**Work Order ID 101368**

Item Name: Crosstube Turning Detail

<b>DART AEROSPACE LTD</b>		<b>Work Order:</b> 101368
<b>Description:</b> Crosstube Assembly (205/212 High Aft)		<b>Part Number:</b> D212-664-241
<b>Inspection Dwg:</b> D212-664-241 <b>Rev:</b> D		<b>Page 1 of 2</b>

DRAWING NO. D212-664-241	TITLE CROSSTUBE ASSY (205/212 HI AFT)	REV. D	DART AEROSPACE LTD ENGINEERING ORDER		D.E.O. NO. D212-664-241-D-1	SHEET NO. SHEET 1 OF 2	SCALE NTS
DRAWN	CHECKED	MFG. APPR.	APPROVED	DE APPR.			
DATE 11.04.07	DATE 11.04.11	DATE 11.04.12	DATE 11/04/12	DATE 11.04.12

D212-664-241/-241B  
ASSEMBLY DETAIL

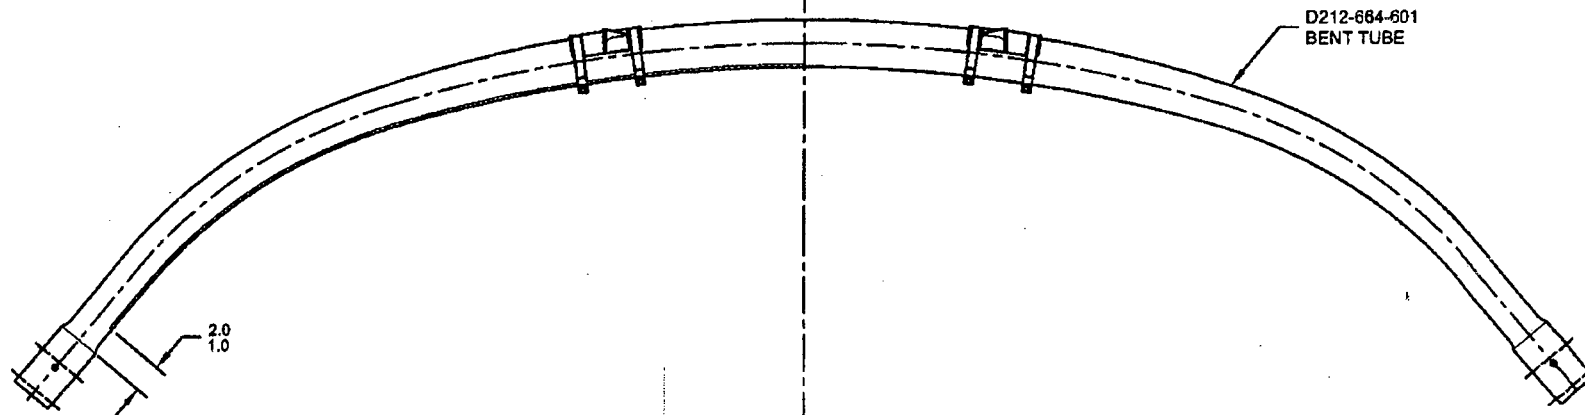
**PURPOSE:**

ADD AN INSPECTION WINDOW TO UNDERSIDE OF CROSSTUBE.

IS:

MASK AREA PRIOR TO PAINTING,  
REMOVE MASKING AFTER PAINT  
AND APPLY CLEAR COAT

- 2) FINISH: CHEMICAL CONVERSION COAT PER DART QSI 005 4.1  
PRIME INSIDE AND OUTSIDE PER DART QSI 005 4.2  
MASK UNDERSIDE OF CROSSTUBE AS SHOWN (HATCHED AREA) AND  
PAINT OUTSIDE PER DART QSI 005 4.2  
REMOVE MASKING AND APPLY CLEAR COAT
